**MINUTES OF THE REGULAR MEETING OF THE
PLAN COMMISSION, VILLAGE OF TINLEY PARK,
COOK AND WILL COUNTIES, ILLINOIS**

May 27, 2021

ITEM #1 VEQUITY MULTI-TENANT REMODEL, 17111-17119 LAGRANGE ROAD – SITE PLAN/ARCHITECTURAL APPROVAL

PLAN COMMISSION STAFF REPORT

SITE PLAN & CIRCULATION

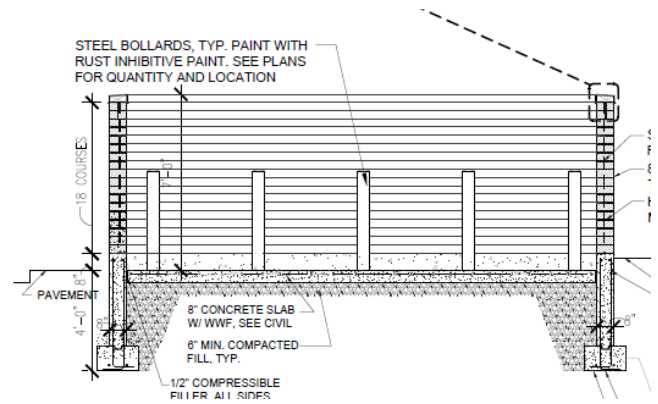
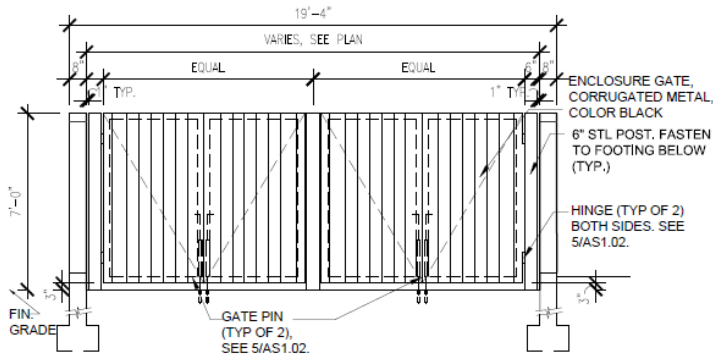
Open Item #1: Review overall proposed Site Plan changes, layout, site circulation, and drive-thru stacking.

The Plan Commission liked the overall site layout and circulation proposed. It was preferred the plans be revised to include some bicycle racks for customers and employees to use.

Above: New west/front elevation with brick framing around the new EIFS area.

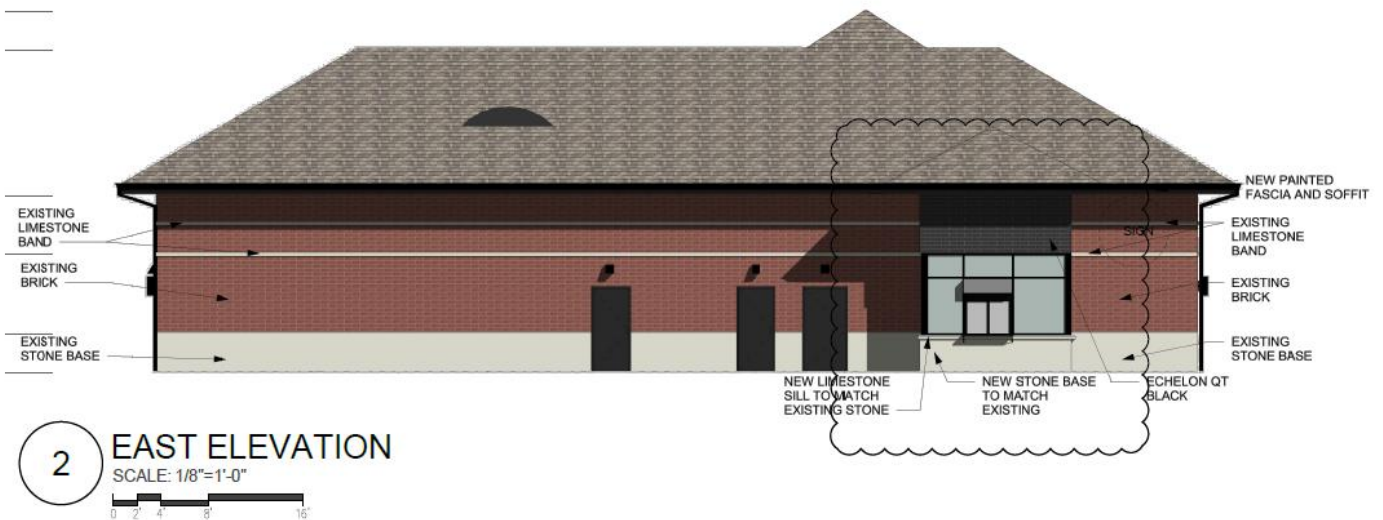
Staff also has concerns with the EIFS addition on the front/west façade as it creates a portion of the façade that looks less appealing than the rest of the building. Staff has recommended that the Petitioner look at alternative options to reduce the EIFS area that includes more brick or the ability to mount signage on the brick on a raceway or backer plate.

Open Item #2: Review façade changes and discuss staff's recommendation that the south façade does not include an EIFS band at the top of the building and there be changes to make the west EIFS band area more appealing.

The Commission noted they agreed with staff on the removal of the EIFS along the south façade that is awkward and ends abruptly. The preference was to see some sort of changes to the front/west façade to add some brick and help frame the EIFS sign area better. The Petitioner revised plans to accomplish the recommendations on both facades and are shown below.

SIGNAGE

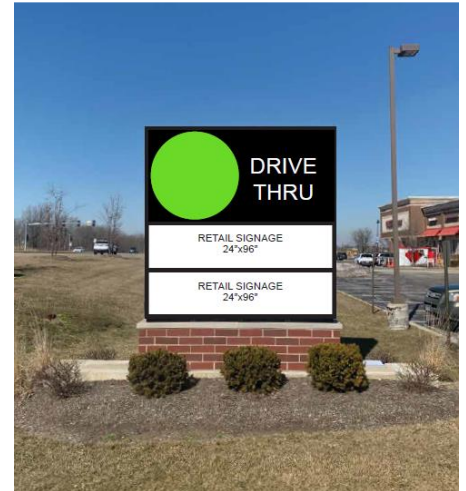
No wall, directional, or drive-thru signage has been proposed at this time. Typically, staff likes to see these signs for any known tenants with new development proposals to avoid any future delays or additional meetings. Specifically, staff notes that a preview menu board, which is typical of Starbucks locations and shown on the site plan, is not permitted (only one sign accessory to a drive-thru is permitted). The Petitioner has noted that all signage beyond the ground sign (wall, directional and drive-thru signage) is the responsibility of the tenants. They have noted it is understood by both them and Starbucks that any signage that isn't in compliance with the existing codes may require a separate review and public hearing process to receive approval.

As requested at the Workshop, the Petitioner cannot request any Variation or Exception from the code requirements for the drive-thru sign because the request was only for Site Plan and Architectural Approval. There is not a public hearing and no ordinance goes to the Village Board. So, an allowance for an additional drive-thru menu sign will require a new application. The need for the information and request was relayed to the Petitioner in their staff review letter of the project. Either they or Starbucks will apply for the Exception once they are closer to permitting for the site and have specific sign details.

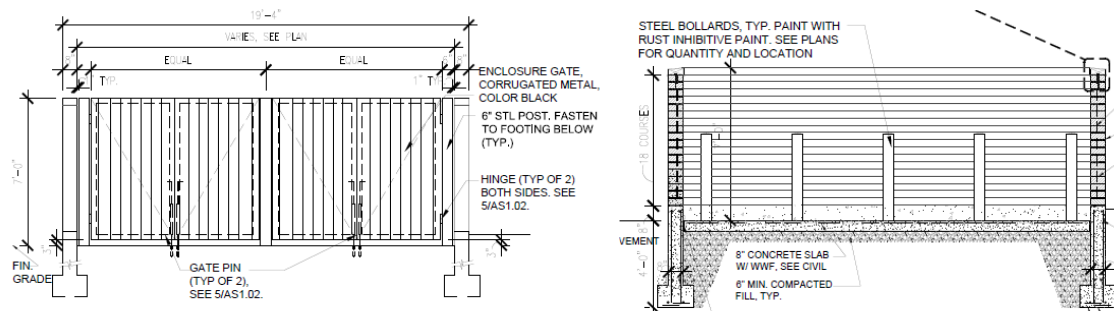
Open Item #1: Review overall proposed Site Plan, layout, site circulation, and drive-thru stacking and the Exceptions required to approve the Site Plan.

The Plan Commission overall like the proposed layout. It was recommended that the Petitioner revise based on the Engineer's review comments to the traffic analysis, including the addition of a stop sign. Additionally, it was recommended that a bike be located on the site for customers and employees. Plans and the traffic analysis were revised to address all of these comments.

Open Item #2: Staff is recommending the site plan approval be conditioned upon final engineering review and approval.

LANDSCAPE ARCHITECTURE

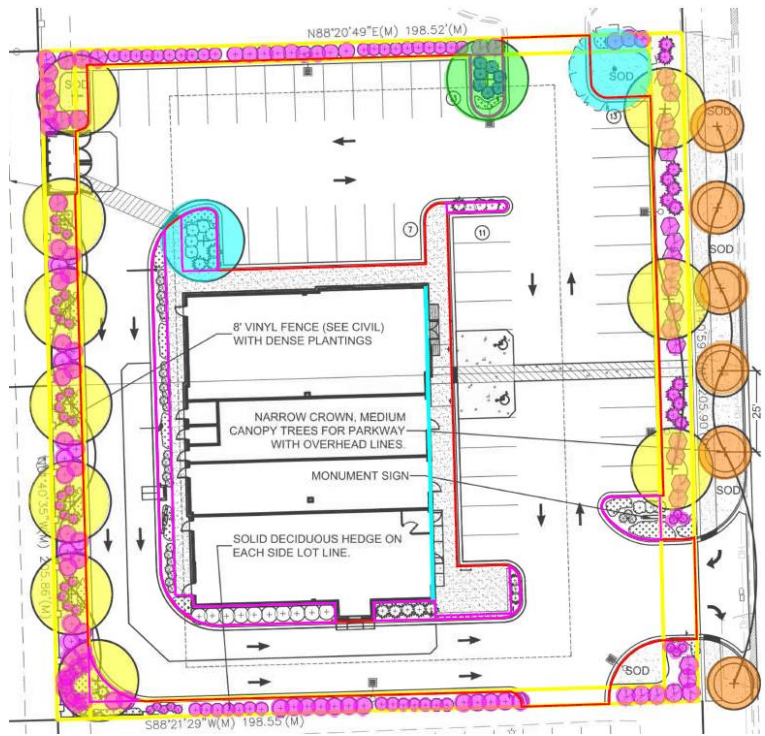
The proposed Landscape Plan has been reviewed by the Village's Landscape Architect and finds it to be in general conformance with the Village's Landscape Ordinance with a few exceptions due to the site's constraints. The proposal requests a waiver from a few of the bufferyard requirements, parkway tree requirements, and interior landscaping requirements. The Petitioner has indicated that they have worked to meet the landscape requirements to the greatest extent possible and focused on making their available bufferyard width and landscaping adequate to buffer views from the residential properties to the west. The requirements of the landscape code are largely designed for new development "green" sites and are more difficult to meet on redevelopment or infill development due to limited site dimensions. When the requirements cannot be met, waivers can be requested, but the goal is to meet the intent of the requirements and create an attractively landscaped site. The total analysis and deficiencies are outlined in the table below.

BUFFERYARD REQUIREMENTS							
Bufferyard Location	Required Width	Proposed Width	Length	Required Plantings	Proposed Plantings	Deficit	Comments
North ("B" Bufferyard)	5'	5'	179'	8 CT 3 US 36 SH	0 CT 0 US 36 SH	-8 CT -3 US -	Overlap of east and west proposed bufferyards excluded.
East ("C" Bufferyard)	10'	10'	206'	11 CT 5 US 42 SH	3 CT 0 US 39 SH	-8 CT -5 US -3 SH	
South ("B" Bufferyard)	5'	5'	179"	8 CT 3 US 36 SH	0 CT 0 US 36 SH	-8 CT -3 US -	Overlap of east and west proposed bufferyards excluded.
West ("D" Bufferyard)	30'	10'	206'	7 CT 4 US 29 SH	7 CT 0 US 67 SH	- -4 US +38 SH	Required plantings reduced by 50% due to proposed fencing. Bufferyard calculations utilize 30' wide requirements.

PARKWAY STANDARDS					
Location	Requirement	Required Trees	Proposed Trees	Deficit	Comments
Parkway	1 Tree per 25 Lineal Feet	7	6	-1	Final plans to ensure low mature height trees to not conflict with existing power lines.

PARKING LOT LANDSCAPING STANDARDS				
Location	Requirement	Provided	Deficit	Comments
Parking Lot	15% of parking lot area to be landscaped or 3,291 square feet	1,680 square feet	-1,611 square feet	21,945 s.f. of parking lot shown on landscape plan
Parking Lot	Screening of adjacent properties and streets.	Continuous screening not provided.	-	Bufferyard plantings counted towards continuous screening requirements.
Parking Lot Islands	1 CT and 1 SH per 200 square feet (2 CT and 2 SH required)	1 CT 7 SH	-1 CT +5 SH	NE island = 169 s.f.

Open Item #3: Discuss the proposed landscape plan and requested Landscape Ordinance waivers.

Plan Commission did not have concerns about the proposed plan. It was largely understood the waivers are due to the limited development area. It was also preferred to see a focus on the western bufferyard having hearty year-round plantings that will help buffer views of the development from the residents.

Two staff recommendations were utilized in the revised plan including the use of evergreen/spruce along the western buffer to allow for year-round screening of the development from the residents to the west. These trees provide for a better visual and noise buffer between commercial and residential properties. Additionally, trees throughout the site have been "upsized" from the minimum requirements to ensure quicker establishment and growth. The evergreen/spruce trees will be planted at an 8-foot height which will allow for quick maturity and additional screening.

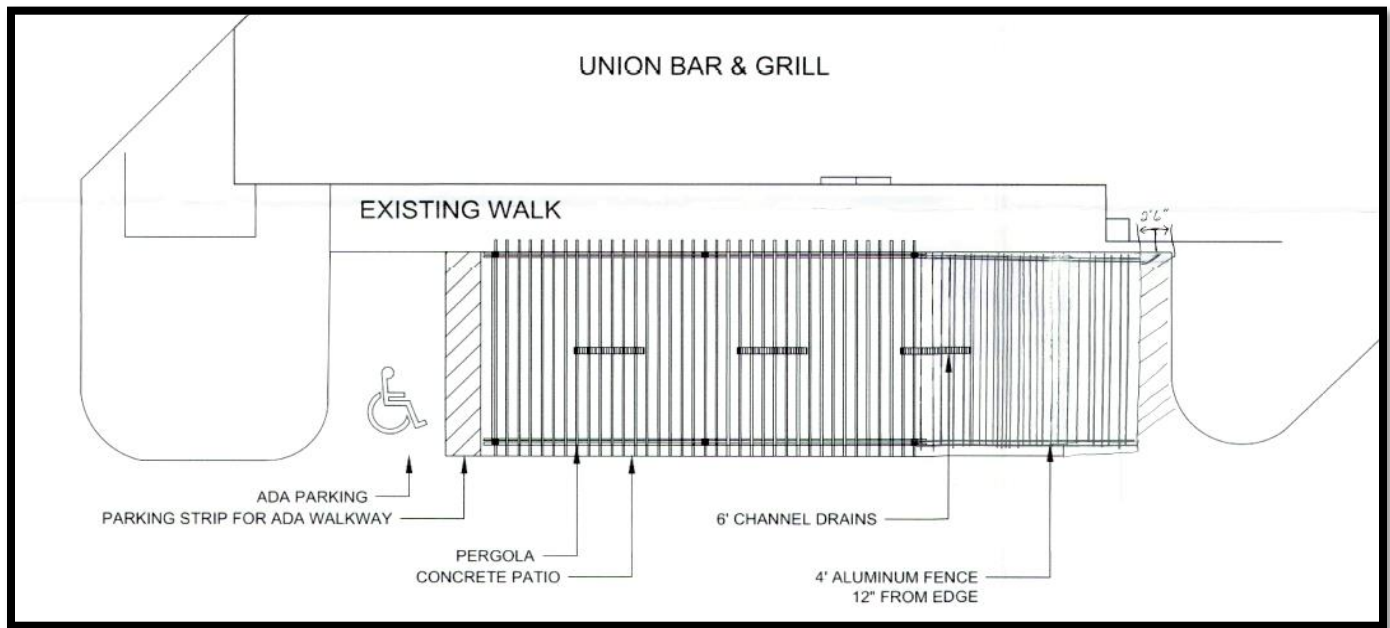
Open Item #1: Review proposed site plan changes with new patio and pergola additions.

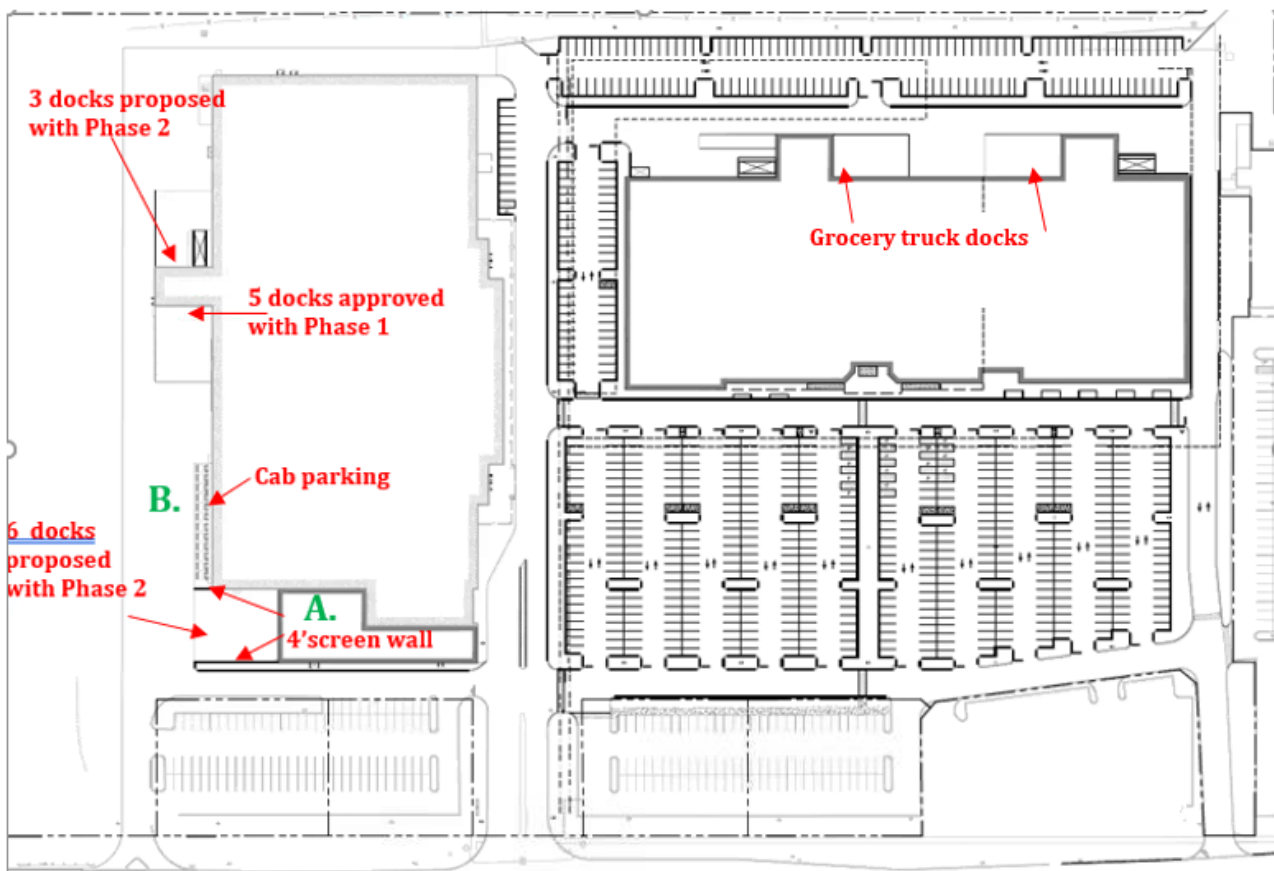
It is staff's contention that retail locations are often 'overparked' resulting in expansive areas of asphalt that are mostly unused and result in high energy, development and environmental costs. As society continues to trend to more efficient modes of travel and less car dependent shopping patterns, it is Staff's opinion that the relationship and proximity of parking to the uses, along with a balance of green space and good circulation patterns, translates to an appropriate parking ratio as proposed. As an exception to the code it will however still need to be noted as part of the PUD approval.

Open Item #1: Identify the parking ratio as an exception to the Village parking requirements.

Outdoor Sales Display.

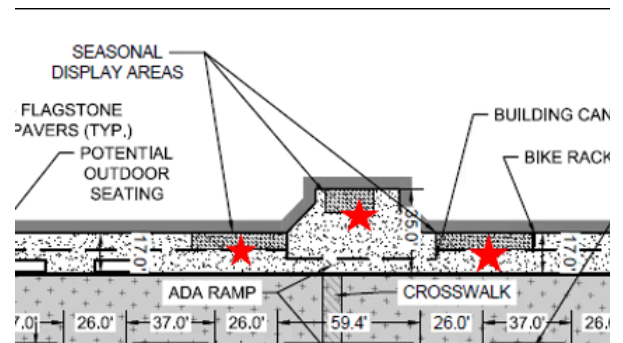
Pete's Fresh Market typically provides outdoor display areas along the frontage of the store. This can be addressed as part of an Outdoor Sales Display Level 1 application which requires administrative approval, however, Level 1 outdoor sales are limited to times between April 15 and October 15. The Petitioner is requesting sales beyond this time frame (for winter holiday displays). PFM has agreed to limit outdoor sales to the areas depicted on the site plan and limit the height of the display to five (5) feet in height. This can be provided within the PUD as an exception.

Open Item #4: Discuss providing for Level 1 Outdoor Sales Display without limitation to the time of year as an exception in the PUD within the designated areas (Plan C1.0) to a height no greater than 5'.
